PROJECT: Summerlin West V25 - Scarry Blvd Drive Improvements

SUBMITTAL: 2nd

CITY OF LAS VEGAS		DATE:
INTER-OFFICE MEMORANDUM		May 5, 2021
TO: Land Development Services Department of Building & Safety		FROM: Albert Sung, P.E. Flood Control Project Engineer Department of Public Works
SUBJECT:	Drainage Study for:	COPIES TO:
Summerlin West V25 - Scurry Bend Drive Improvements (from Sunset Run Dr. to Lake Mead Blvd.)		Atkins
Cross Streets:	Scurry Bend Drive. & Lake Mead Boulevard	Howard Hughes Company, LLC
File Number:	F:\Depot\DSMemos\DS5427B.doc	Bart Anderson, P.E., DevCo
Parcel Number:	137-15-801-002 & more	
Zoning Action:	N/A	
FEMA Flood Zone	YES NO X	
Proposed Storm Drain	YES X NO

Summerlin West Village 25

DESIGNED BY: B. MOCHTYAK
DRAWN BY: K. HENDRY
CHECKED BY: N. BARCOS
DATE: APRIL 2021
DRAWING NO.: 18/42
JOB NO.: 100069098

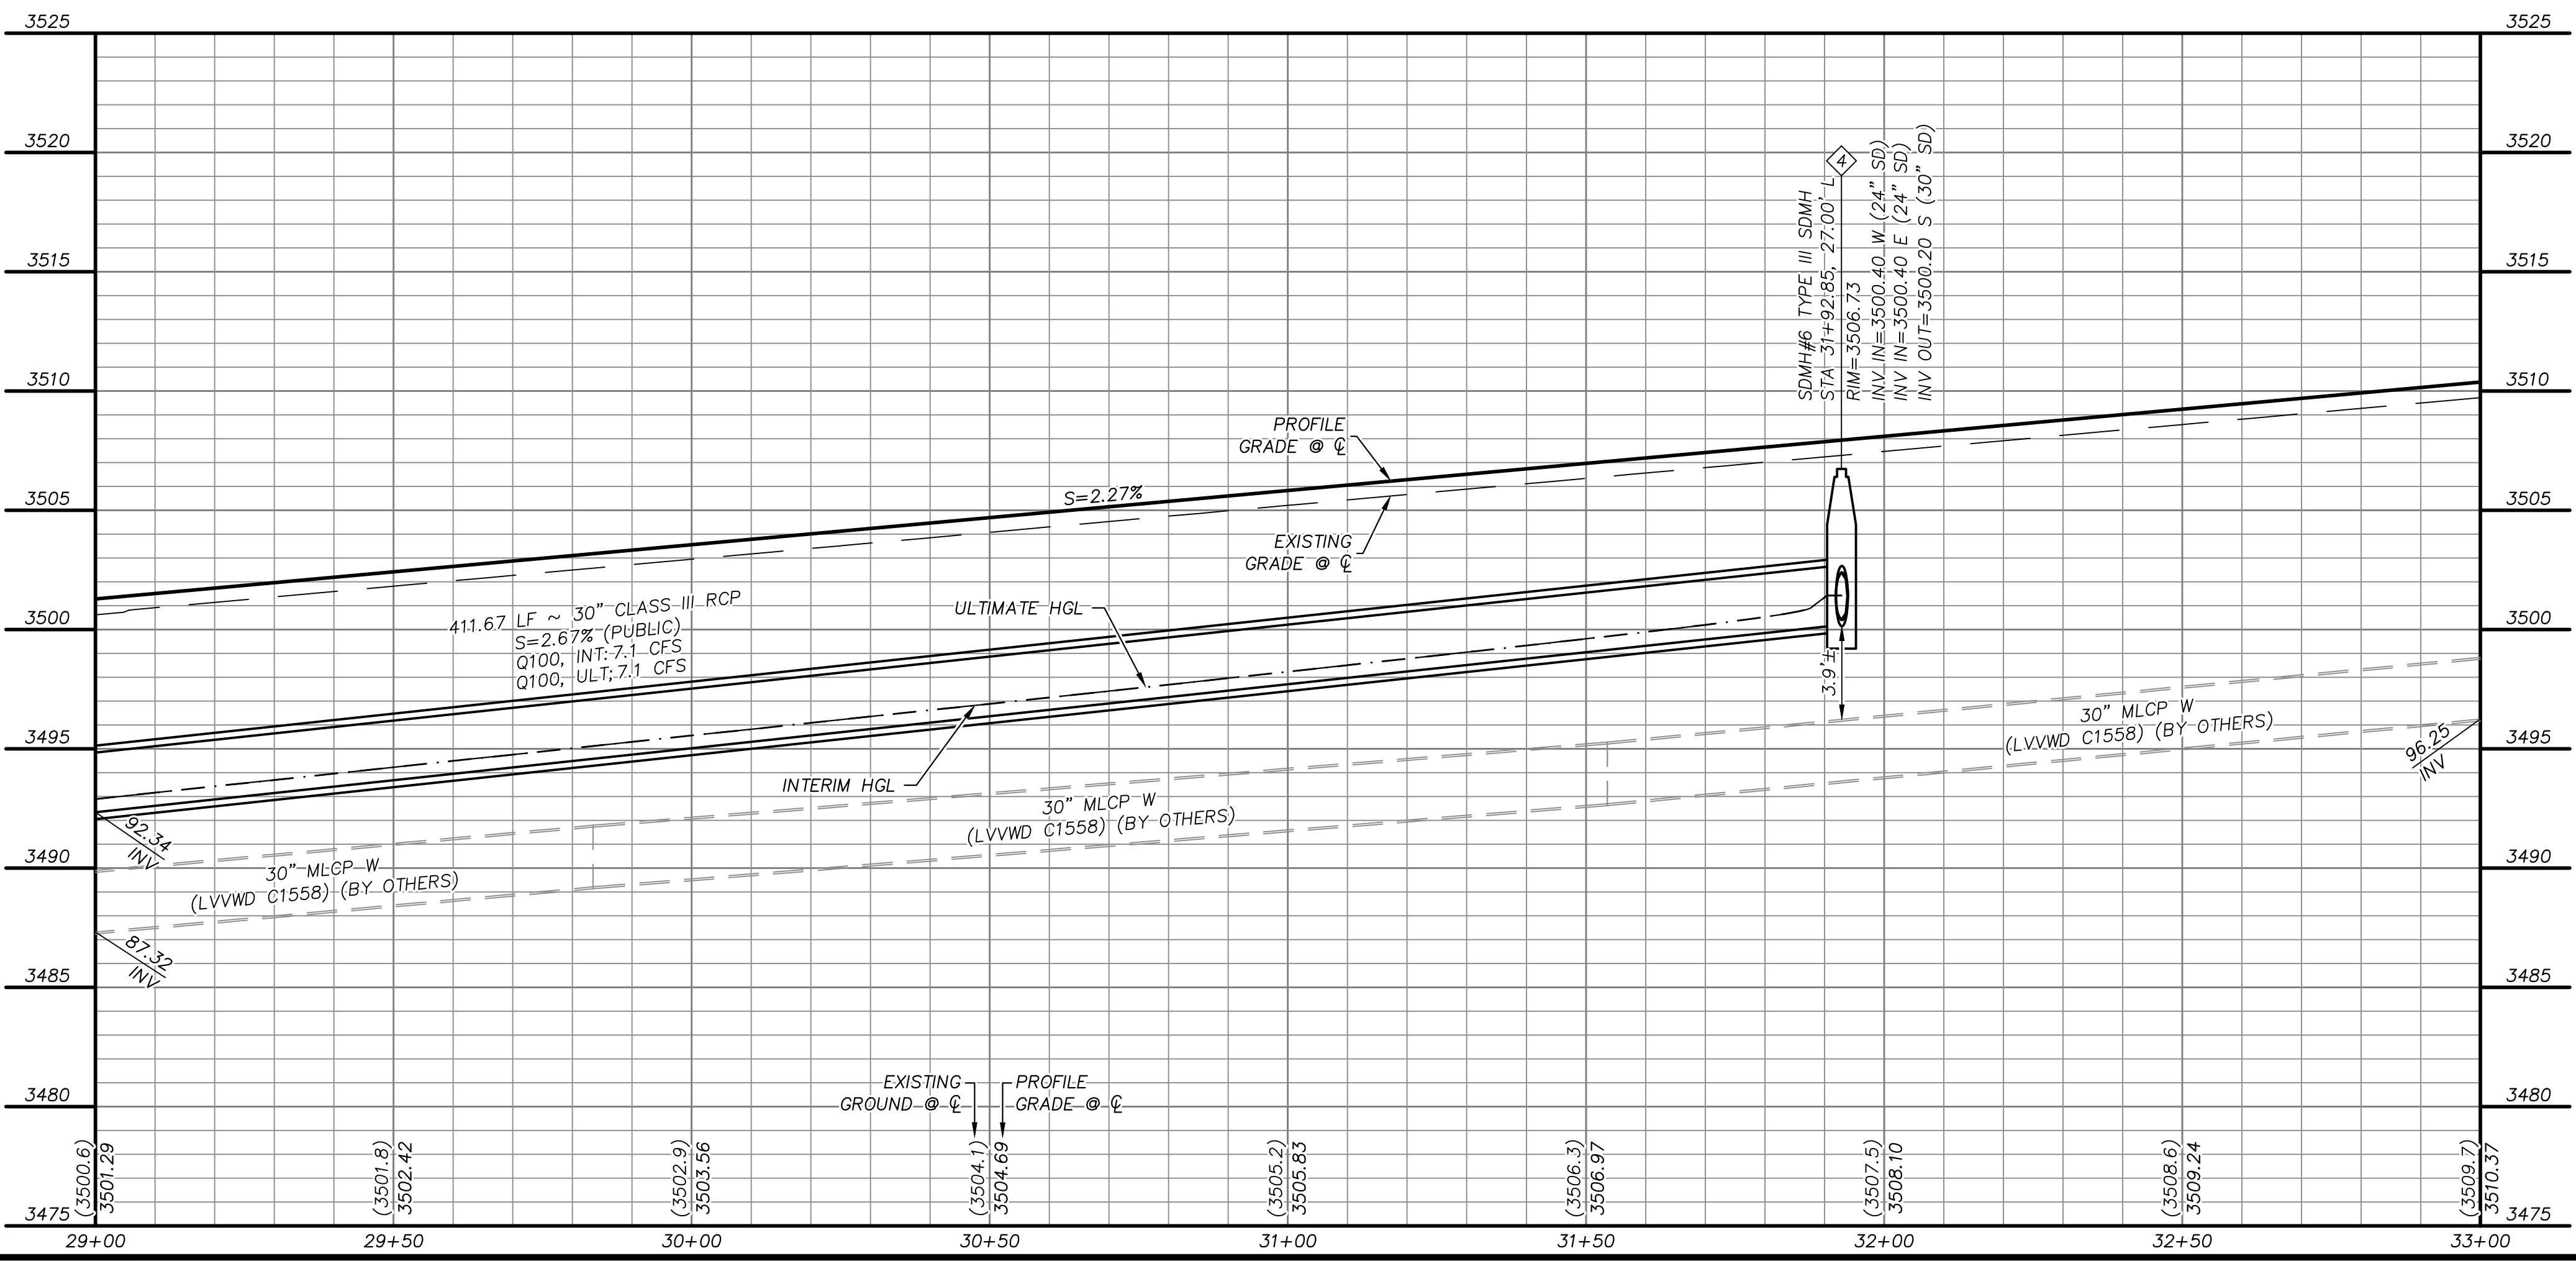
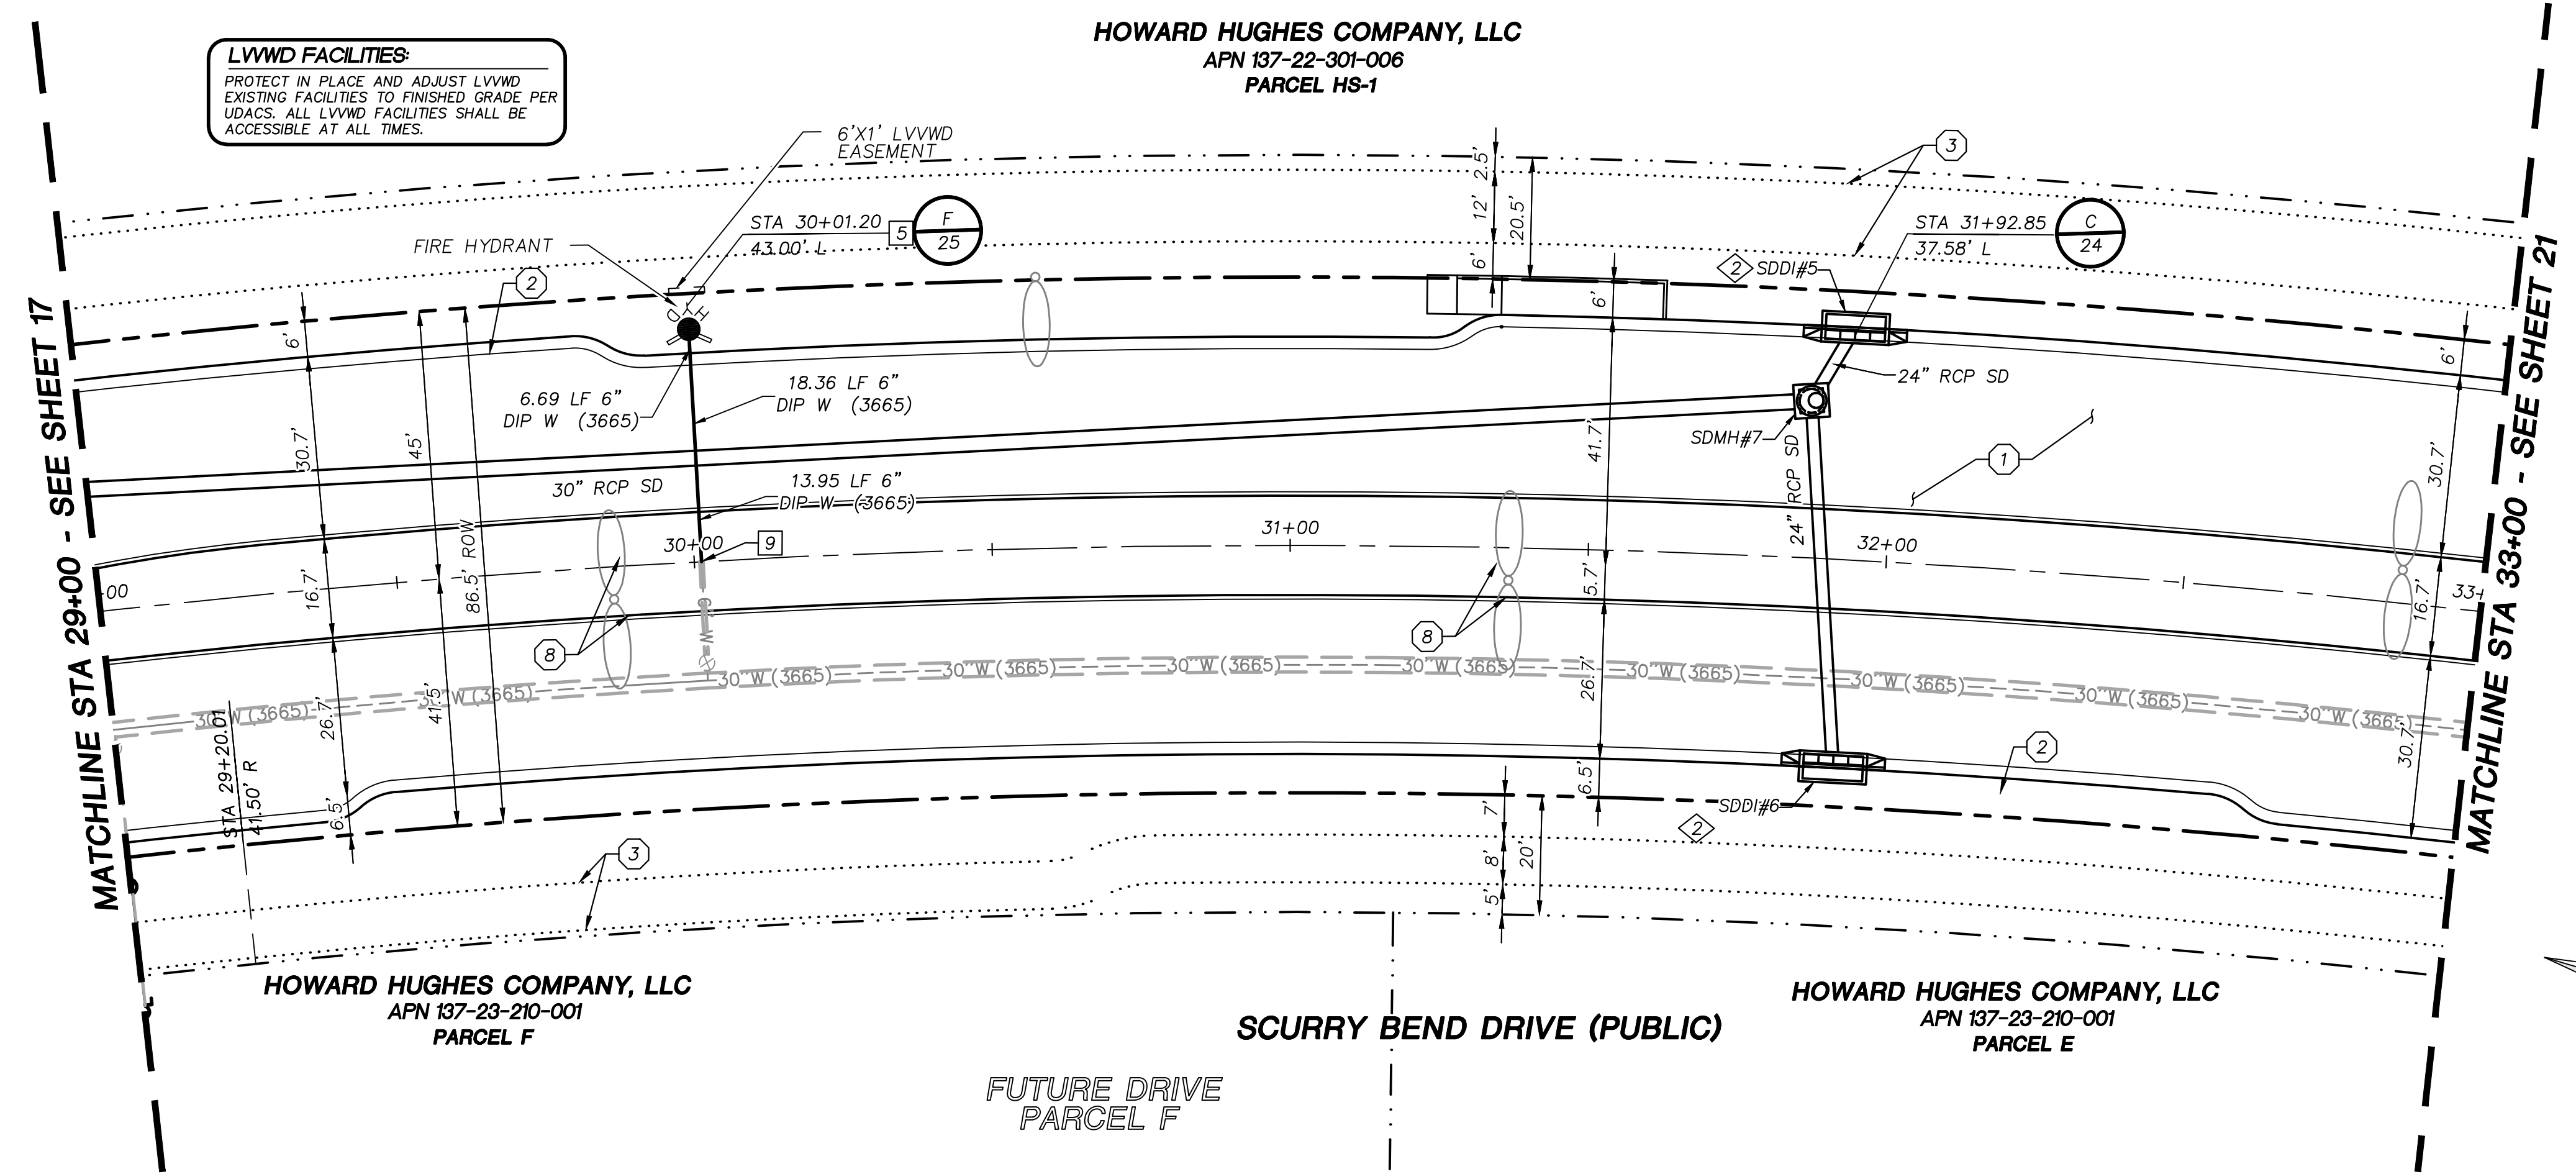
Comment #16: *The inlets shown on the roadway grading plan Sheet 18/42 are missing the SDDI number labels. Should show SDDI#5 and SDDI #6.*

DESIGNED BY: B. MOCHTYAK	DATE: APRIL 2021	DRAWING NO. 22/42
DRAWN BY: K. HENDRY	DATE: APRIL 2021	VERT.: NONE
CHECKED BY: N. BARCOS	DATE: APRIL 2021	
APPROVED BY: NICOLAS BARCOS	DATE: APRIL 2021

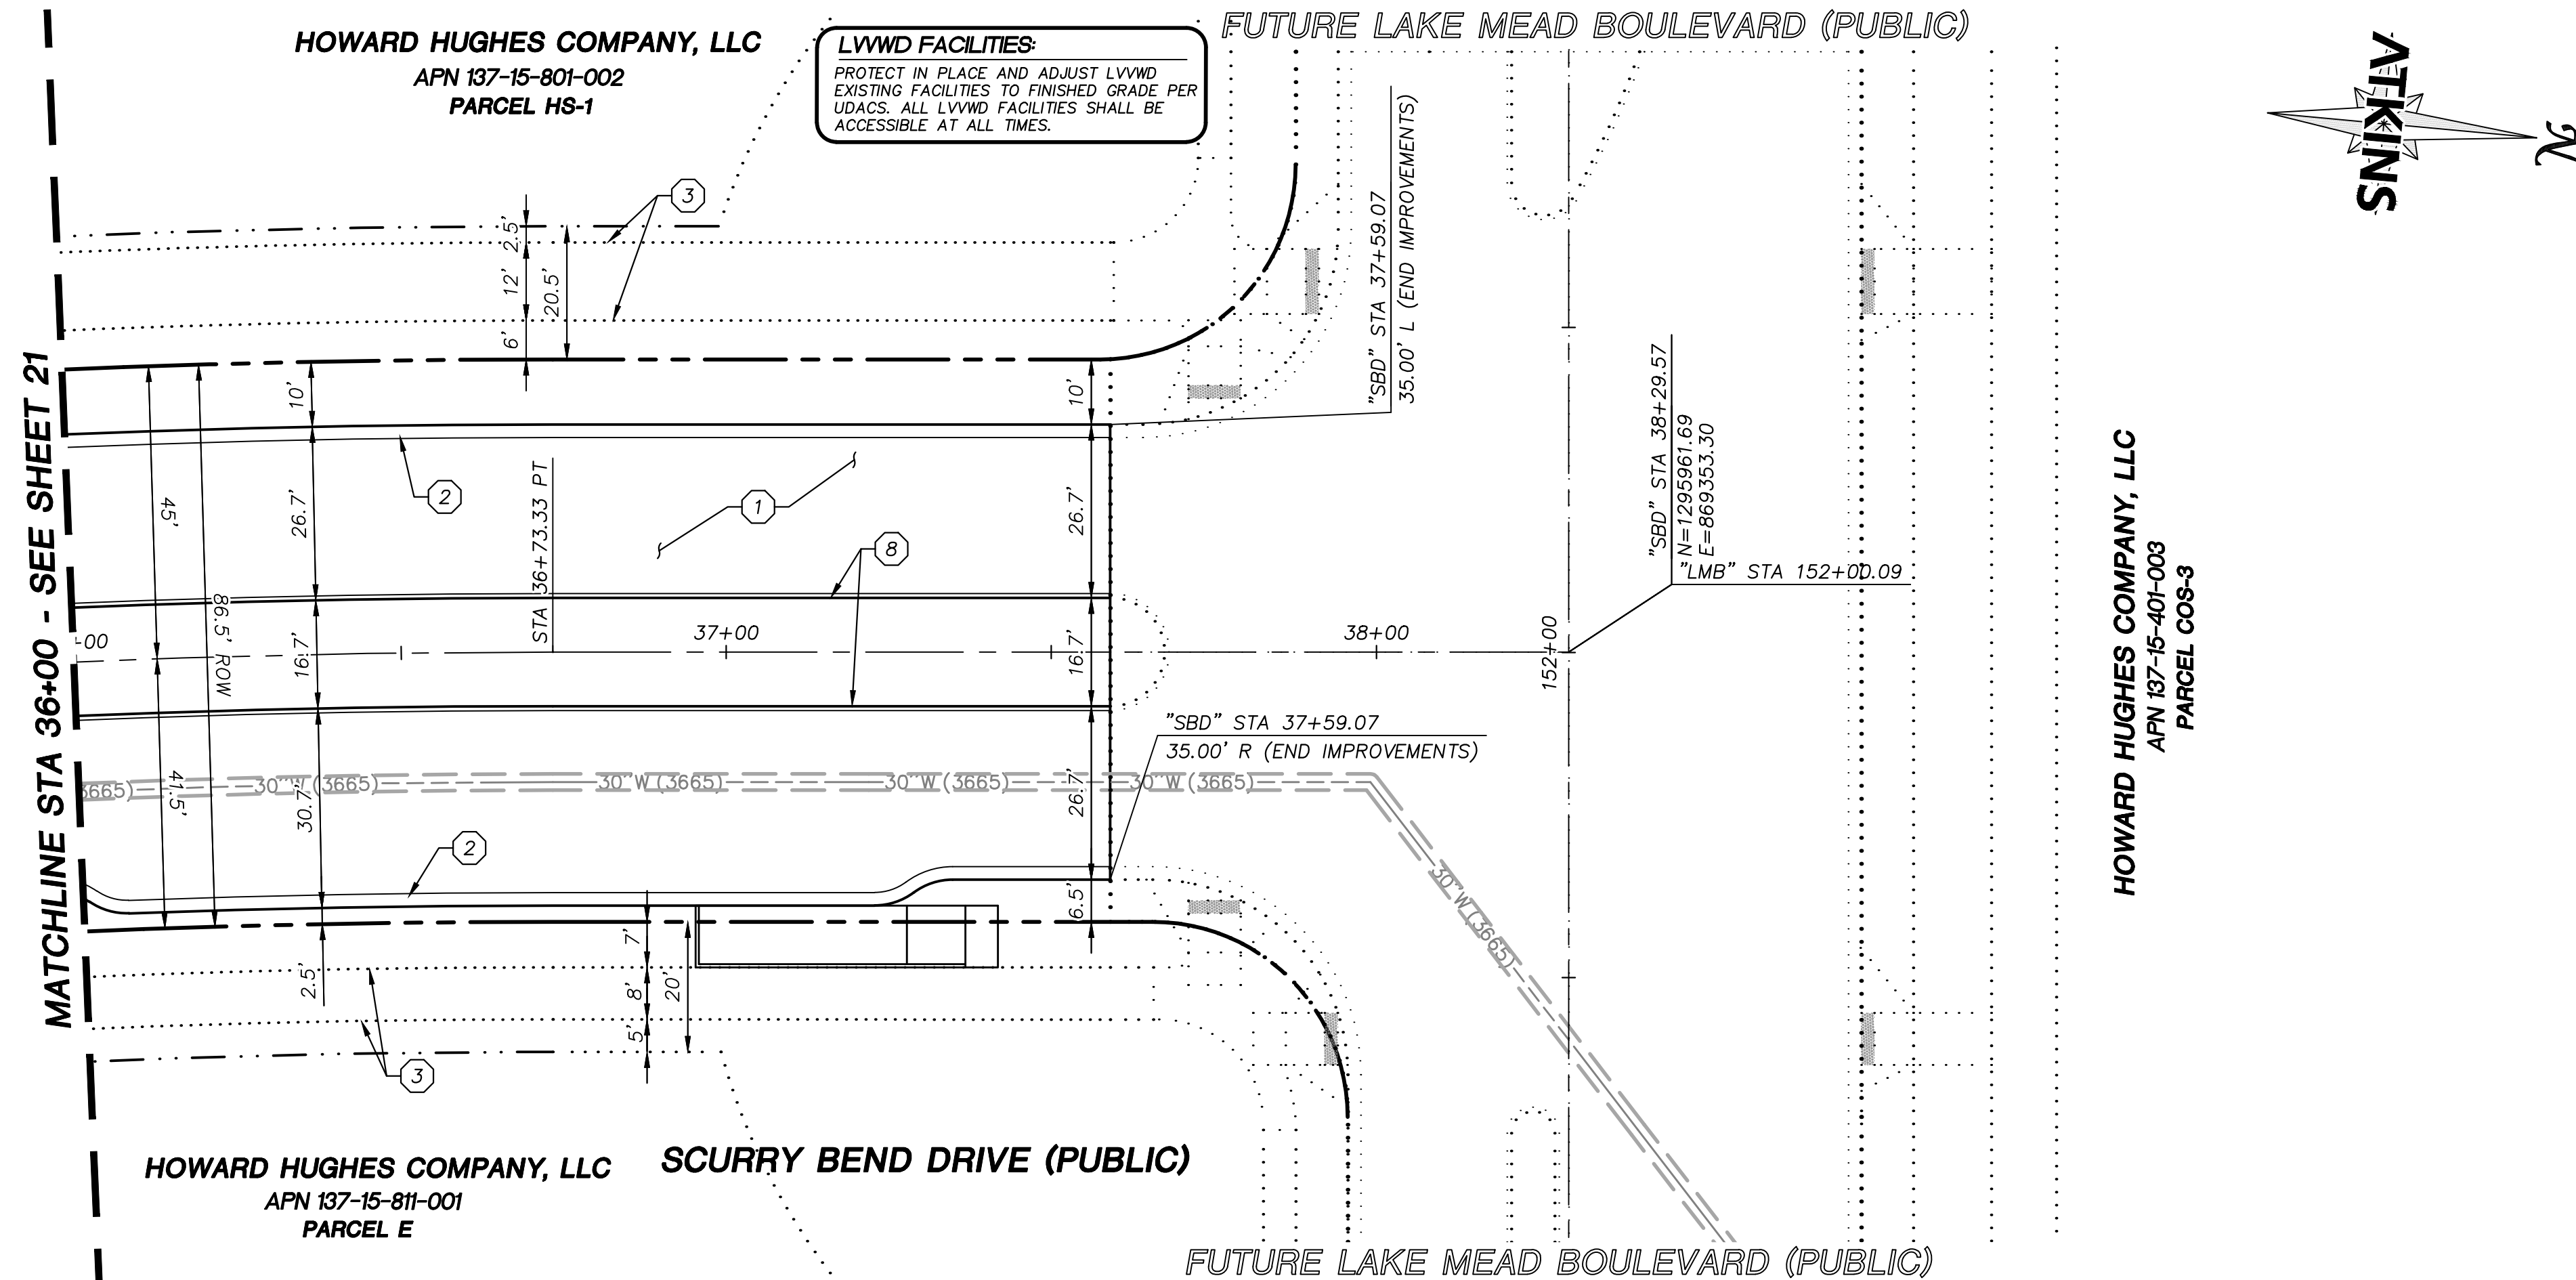
5. **Previous Comment #17:** *Sheet 22/42 and Sheet 23/42: Discuss about whether there will be any inlets in the future Lake Mead Boulevard upstream of the intersection with Scurry Bend Drive. If there are none and to meet the 600'-maximum spacing requirement for inlets, the storm drain may need to be extended from SDMH #7 and two nominal inlets be provided in the vicinity of the intersection of the two roadways.*

Comment #17: *Sheet 22/42 and Sheet 23/42: Discuss about whether there will be any inlets in the future Lake Mead Boulevard upstream of the intersection with Scurry Bend Drive. If there are none and to meet the 600'-maximum spacing requirement for inlets, the storm drain may need to be extended from SDMH #7 and two nominal inlets be provided in the vicinity of the intersection of the two roadways. Address and resolve in the next submittal.*

The response is that there will be a drop inlet in *Lake Mead Boulevard* upstream of the intersection with *Scurry Bend Drive*. Show as such the inlet on *Sheet 22/42* and *Sheet 23/42* as "Future" in the next submittal.
